NINE MILE POINT NUCLEAR STATION, UNIT NO. 1

AMENDMENT TO FACILITY OPERATING LICENSE

Amendment No. 41  
License No. DPR-63

ATTACHMENT TO LICENSE AMENDMENT NO. 41

Figure 3.1.7d Maximum Allowable Average Planar LHGR Applicable to P8DNB277 and Future Reload Fuel as described in Reference 8.

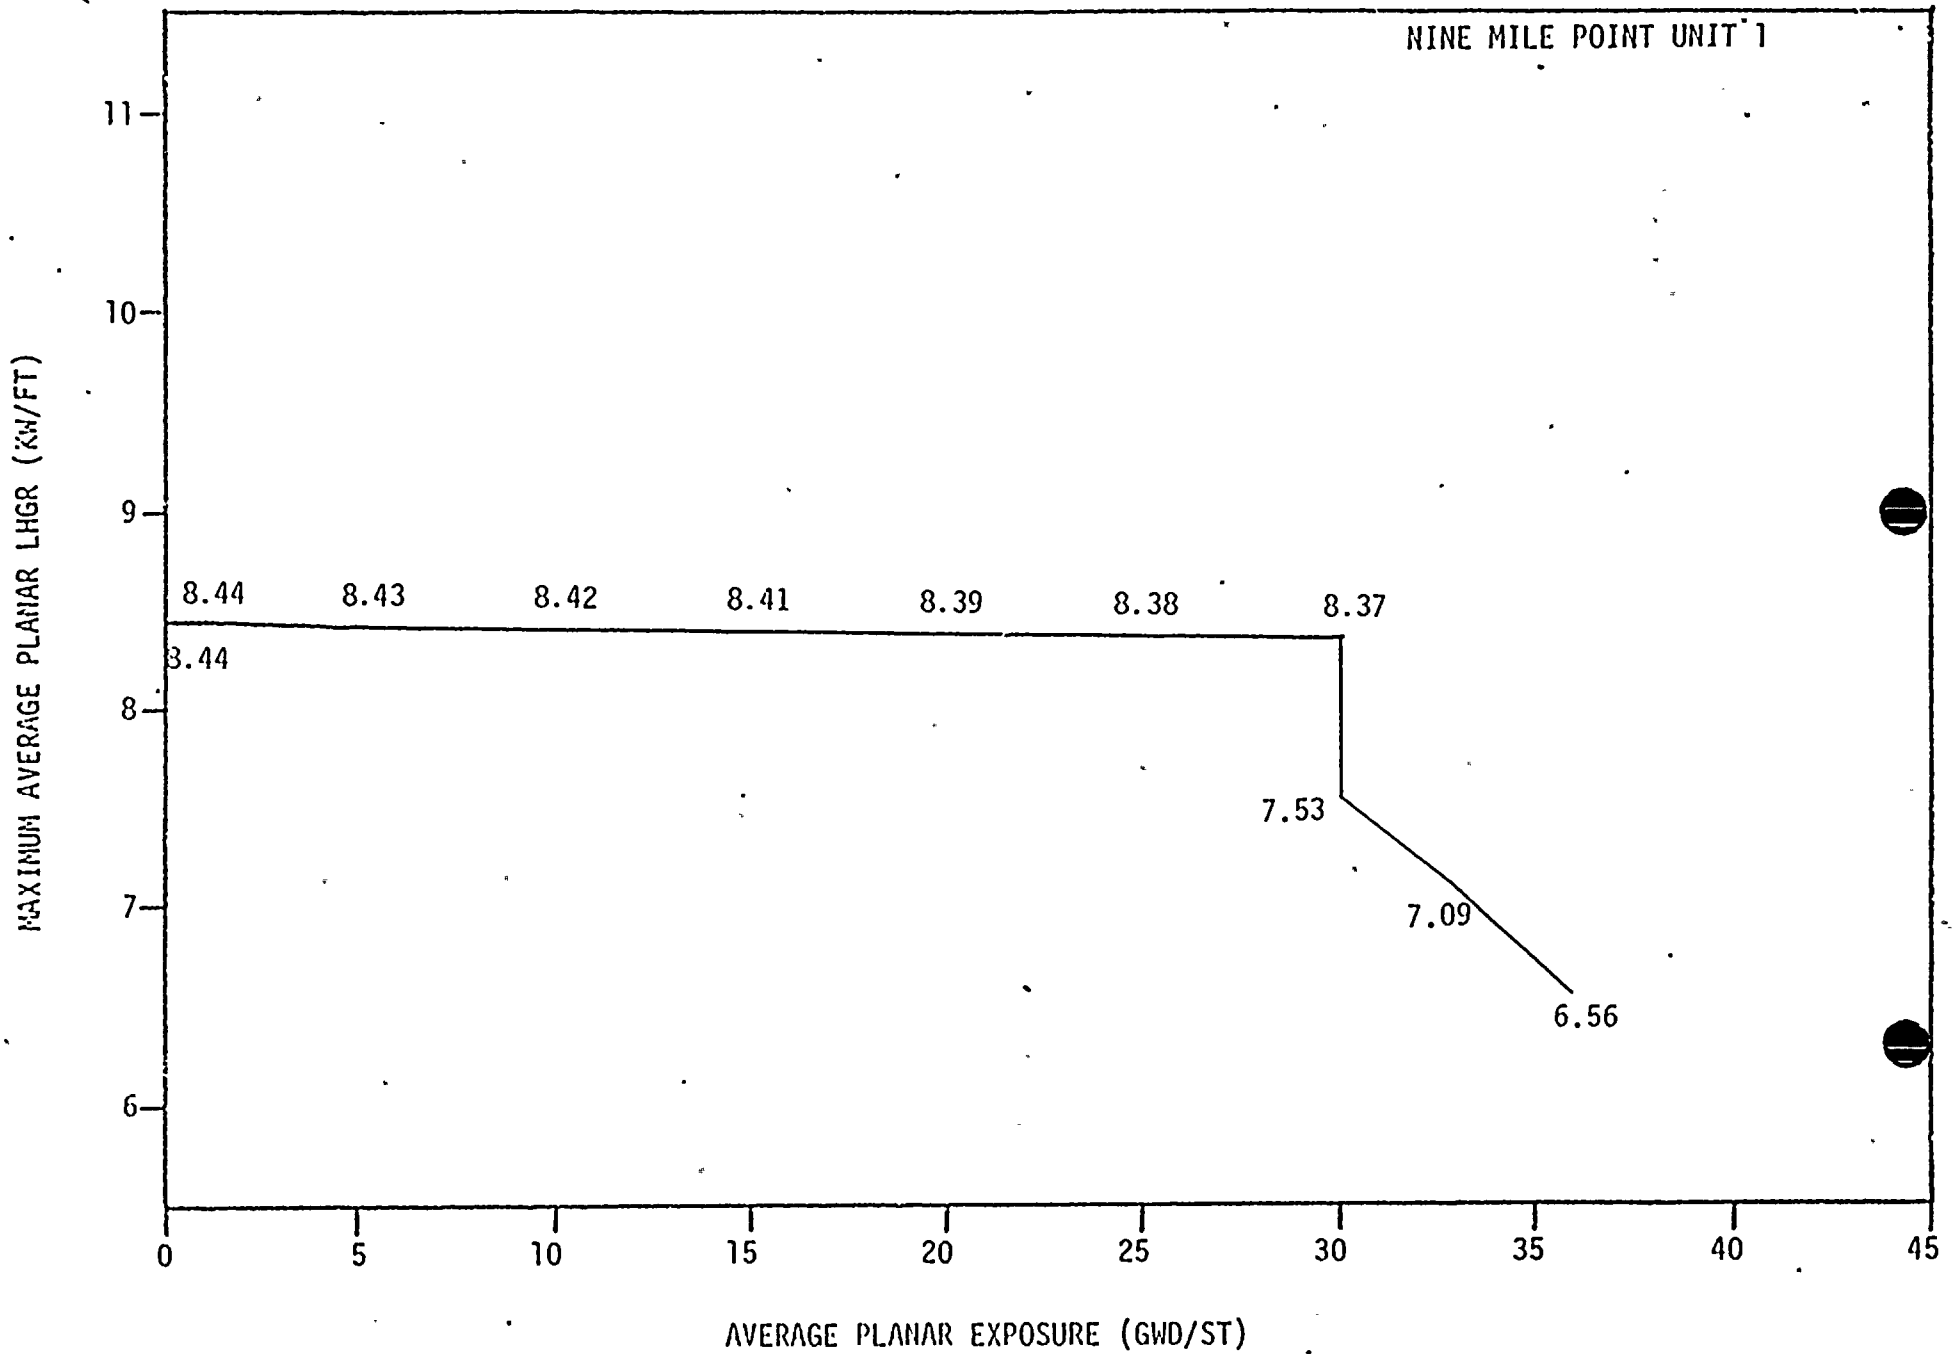
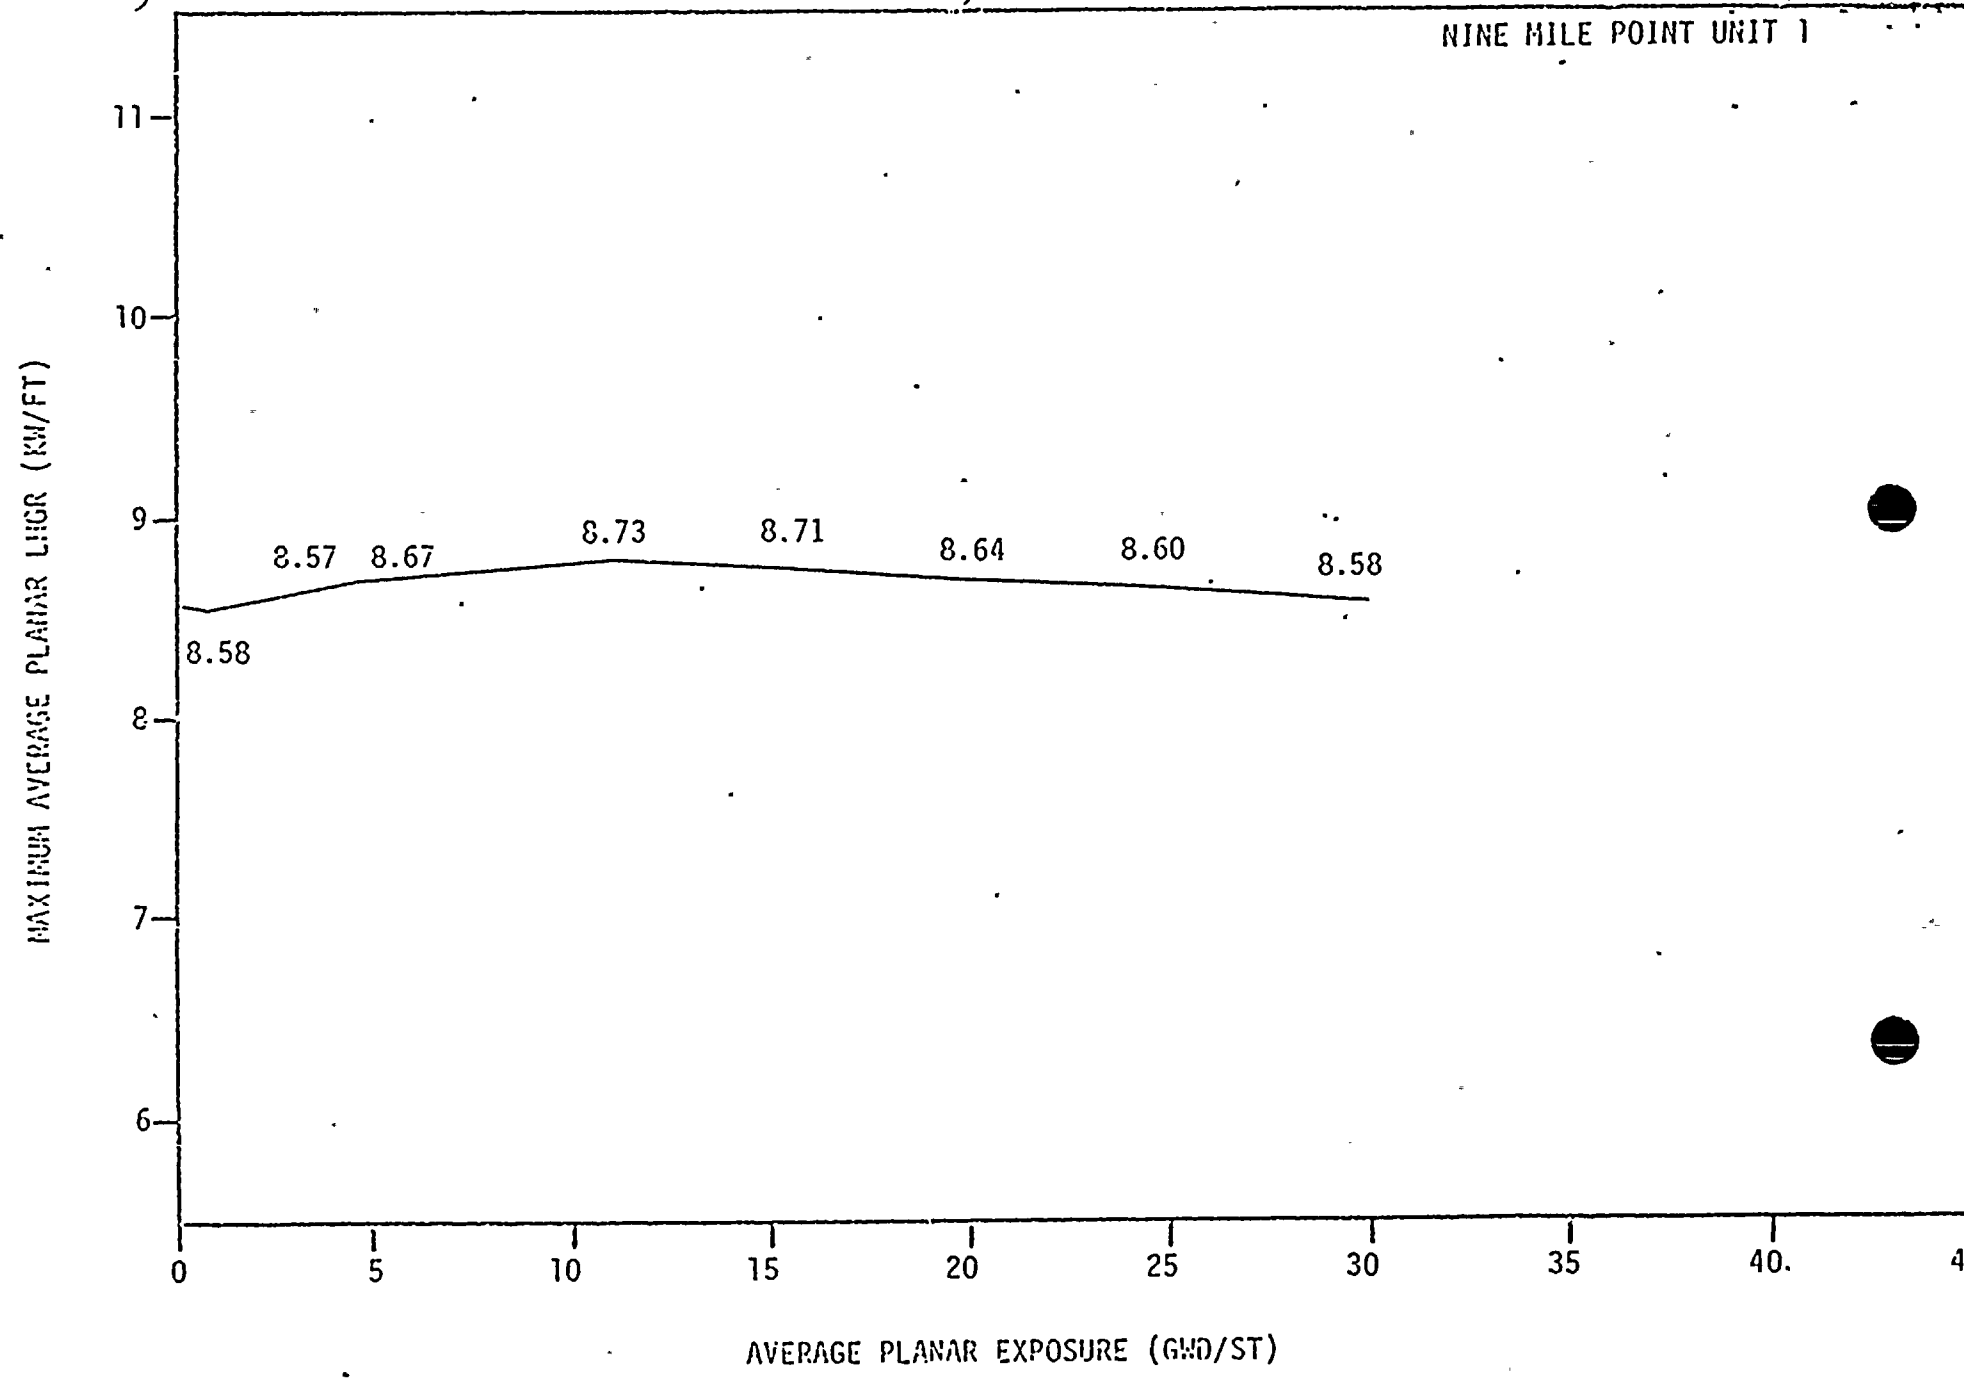
During power operation, the APLHGR for each type of fuel as a function of average planar exposure shall not exceed the limiting value shown in Figures 3.1.7a, 3.1.7b, 3.1.7c, 3.1.7d and 3.1.7e. If at any time during power operation it is determined by normal surveillance that the limiting value for APLHGR is being exceeded at any node in the core, action shall be initiated within 15 minutes to restore operation to within the prescribed limits. If the APLHGR at all nodes in the core is not returned to within the prescribed limits within two (2) hours, reactor power reductions shall be initiated at a rate not less than 10% per hour until APLHGR at all nodes is within the prescribed limits.
